TO: Mayor R. Eric Clarkson
ATTN TO: Rebecca Keefer, Interim Planning & Development Director
FROM: Douglas R. Hooker, Executive Director
RE: Development of Regional Impact (DRI) Review

Name of Proposal: Chamblee Park DRI #3292

Review Type: Development of Regional Impact **Date Opened:** May 21, 2021 **Date Closed:** June 7, 2021

DRI SITE PLAN

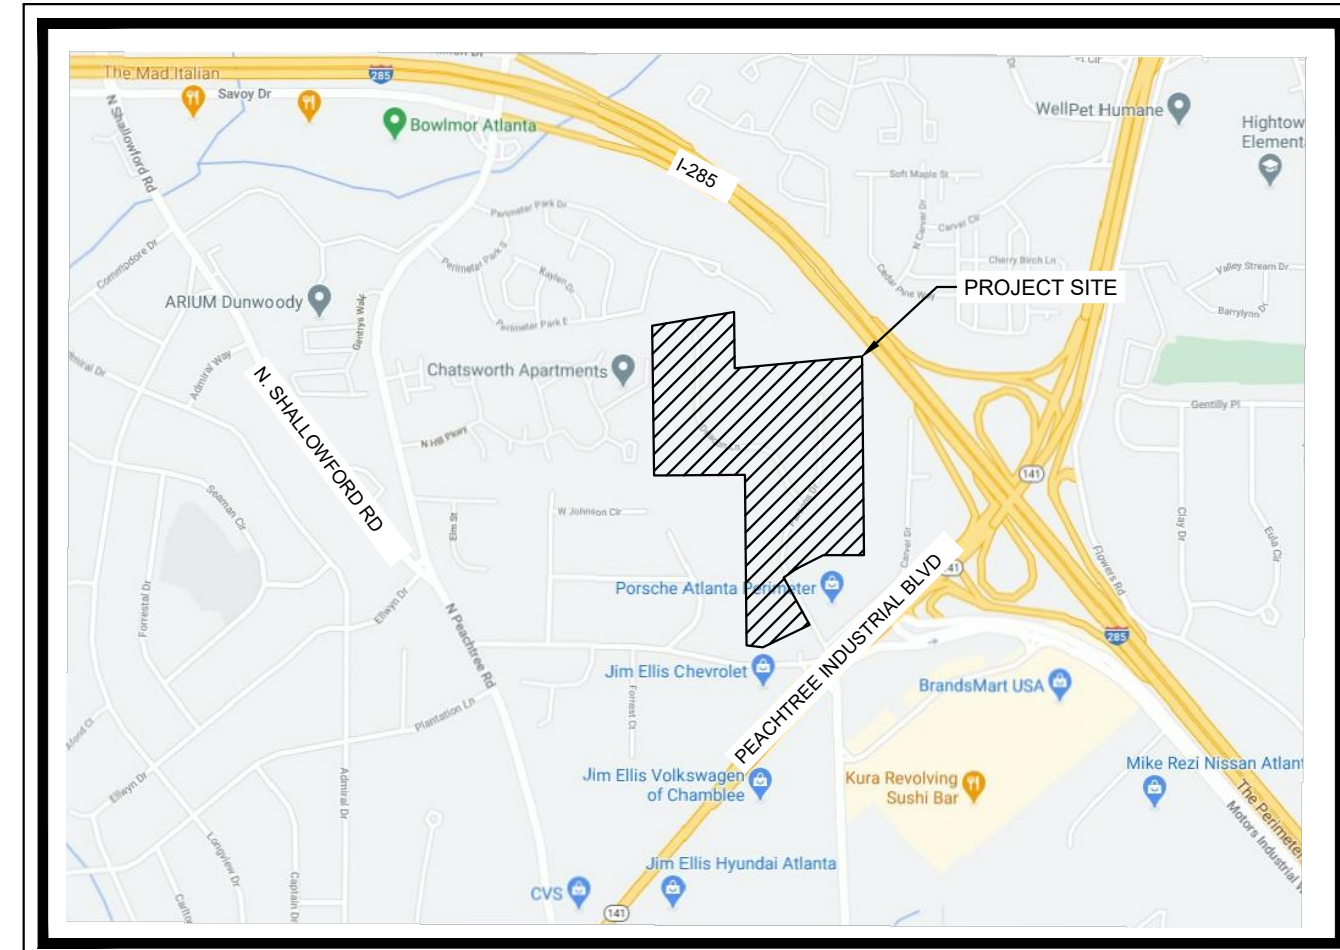
A critical part of making this project an integrated part of the community with more transportation options will be making the northern street connection to Perimeter Park Drive to allow trips to be distributed on both ends. Otherwise the project will effectively be a dead-end with all trips funneled to one intersection that is already challenged with delays. The accompanying traffic study was conducted with the expectation of the future northern access. If for whatever reason this connection is not possible, a new traffic study should be required to understand the impacts with a single access point. Please see the attached comment from City of Doraville, which agrees the northern access is critical.

The sidewalks must be continued from the southern property line to the intersection of Peachtree Industrial Boulevard. It's hard to see the point of bothering with the expense and effort of building a fully accessible and inviting pedestrian experience within the project when it ends abruptly for anyone attempting to leave the project on foot. Considering that the GRTA-required traffic study for the DRI recommends no other improvements to the transportation network to address vehicular delays, this seems like a reasonable expectation for the applicant to improve neighborhood connectivity when adding a significant amount of density to a formerly low-density location. The One Chamblee plan notes that the City contains 93 miles of streets with 56 miles of sidewalks. Addressing this gap requires pursuing every opportunity that redevelopment provides.

The 2019 One Chamblee Comprehensive Plan identifies the potential for a mixed pedestrian/bike trail through the length of the DRI. The current site plan doesn't appear to show room for this trail either along the western edge of the DRI site or on the internal street. It's possible that a safe and comfortable bicycle option through the DRI could be possible with a variety of wayfinding and traffic calming measures, or a side path running along the eastern side of the internal street where there are fewer conflicts with motorists. The City should immediately discuss these options before the site plan is finalized to allow flexibility for the City's long-term connectivity goals. More design considerations and recommendations can be found at <https://atlantaregional.org/plans-reports/bike-pedestrian-plan-walk-bike-thrive/>.

The project can further support The Atlanta Region's Plan in general by incorporating other aspects of regional policy, including green infrastructure and/or low-impact design, e.g., pervious pavers, rain gardens, vegetated swales, etc., in parking areas and site driveways, and as part of any improvements to site frontages. Additional comments from ARC's Natural Resources Group are attached. They note that the project is within the Nancy Creek watershed, which means there is the future potential of it being included a large water supply watershed for the Chattahoochee River. It also notes that variances may be required for the portion of the stream shown on the site plan extending into the proposed parking deck.

The USGS coverage for the project area shows no streams on or near the property. However, the submitted site plan shows a stream just west of the project property, with a short stretch within one corner of the property. The City of Chamblee 50-foot undisturbed buffer and 75-foot impervious setback, as well as the State 25-foot Erosion and Sediment Control Buffer are shown and identified. No intrusions are proposed where the stream cuts across a corner of the property. However, the stream is also shown ending at the property line near Peachtree Industrial Boulevard. A proposed parking lot is shown in that area. If the stream extends into the proposed parking lot, variances may be required. Any other unmapped streams identified on the property may be subject to the City of Chamblee's stream buffer ordinance, and any unmapped State waters identified on the property will be subject to the State 25-foot Sediment and Erosion Control buffer.
